Field Service Bulletin

Subject: 5300 SEM or UCM model mobile radios shipped through August 23, 2004
Units can be identified by the serial number revision letter. Affected units are rev G or H.
Example: 53170G164A 12345

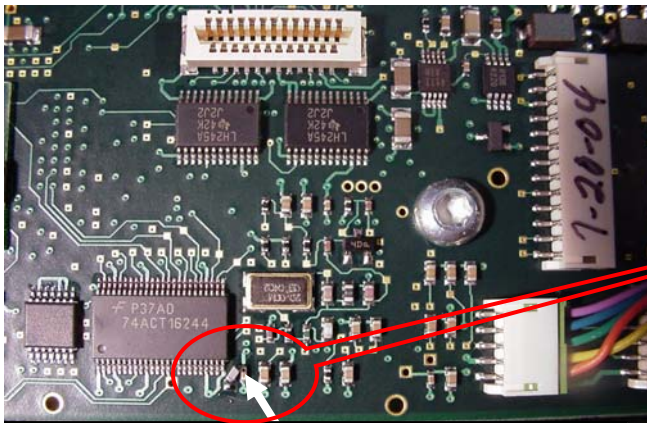
1. The addition of a 470pf capacitor to the SEM/UCM board
2. The moving of a jumper on the SEM board
3. The upgrade to the latest Q2 Software Release: SEM 2.4.8 or UCM 3.4.4
4. The use of the latest PC Configure software 1.24.0

The addition of a 470pf capacitor to the SEM/UCM board:

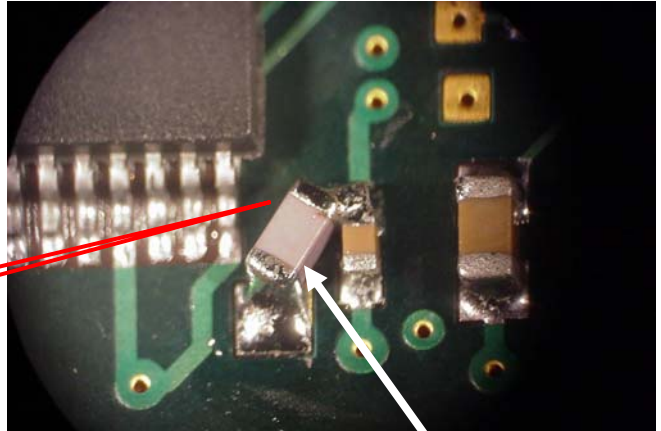
Add 470pf cap on SPICLK line to 5v supply

Solder 510-3674-471 '603' 470pf cap between TP45 and C30
